Interactive comment on “Reservoir storage and hydrologic responses to droughts in the Paraná River Basin, Southeast Brazil” by D. C. D. Melo et al.

Received and published: 16 September 2016

Fig. 1. Spatial variation of the Standardized Precipitation Index (SPI) and Streamflow Index (SDI) in the period of two droughts.

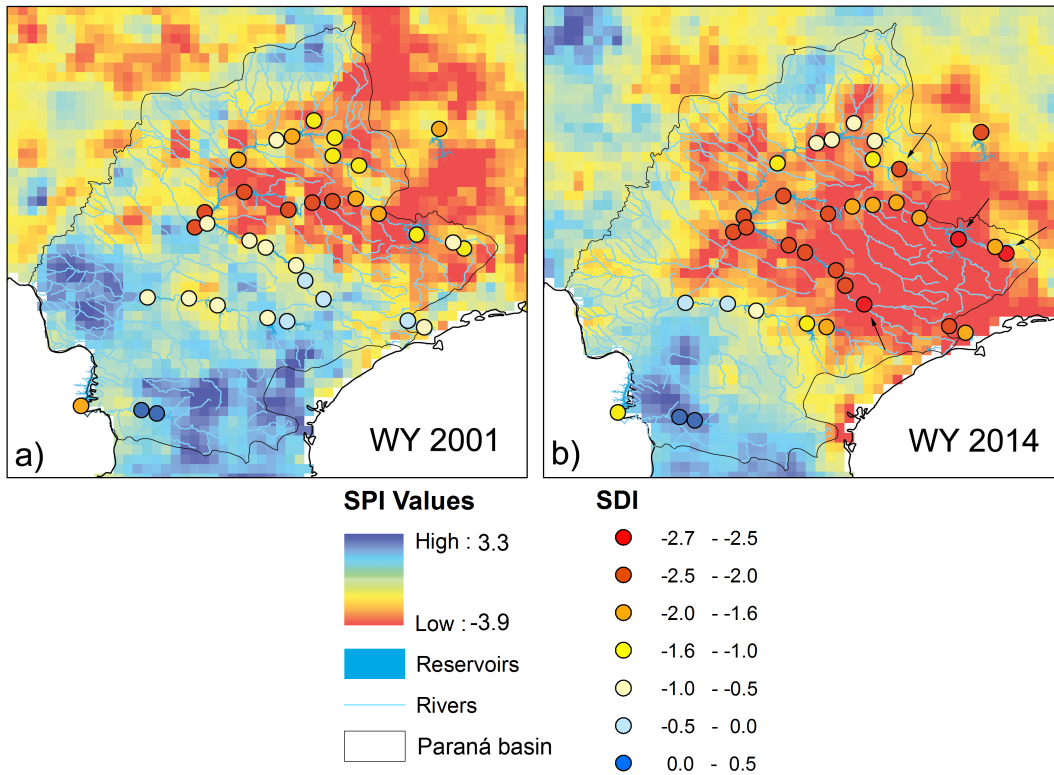
Page 5, lines 5-20: One of the study objectives was to identify the intensity, duration and extent of the droughts at the Parana watershed. It was clear what the periods of 2000 and 2014 had droughts and its duration and intensity (analyzing Figure 2). But for the spatial extent I think it could have been made a simple figure showing the spatial variation of the SDI/ SDI within the period of each drought, showing yet an outline of the area affected by the drought.

Response: The attached figure (Fig 1) was inserted in the manuscript. The following description and discussion about the figure was inserted in the Section 3.4.

“Streamflow data were used to calculate the Streamflow Drought Index and provide insights on linkages between meteorological and hydrological droughts (Fig. 6) for water years 2001 (WY 2001) and 2014 (WY 2014). In general, meteorological droughts resulted in hydrologic droughts, as indicated by the extreme low values of SDI where SPI

was negative (Fig. 6). However, some upstream reservoirs (highlighted with arrows) seem to have buffered the effects of the 2014 drought in the downstream reservoirs. Although SPI indicate a severe to extreme dry situation ($SPI < -2$) over those reservoirs, SDI increased from upstream ($SDI < -2.50$) to downstream ($-2.5 < SDI < -2.0$). This means that the river discharge deficit (hydrologic drought) caused by the meteorological drought was (modestly) attenuated by the upstream reservoirs. Comparison between WY 2001 and 2014 show the greater spatial extent of the most recent drought within the Parana basin (PB), which agrees with the rainfall anomaly in Fig. 3. Except for the south and central south of the PB, the extent of the hydrologic drought was more critical in WY 2014 than in WY 2001. For instance, the same sub-basin in the center of PB had, in WY 2001, $-1 \leq SDI \leq 0$, whereas, in WY 2014, $-2.7 \leq SDI \leq -2.0$.”
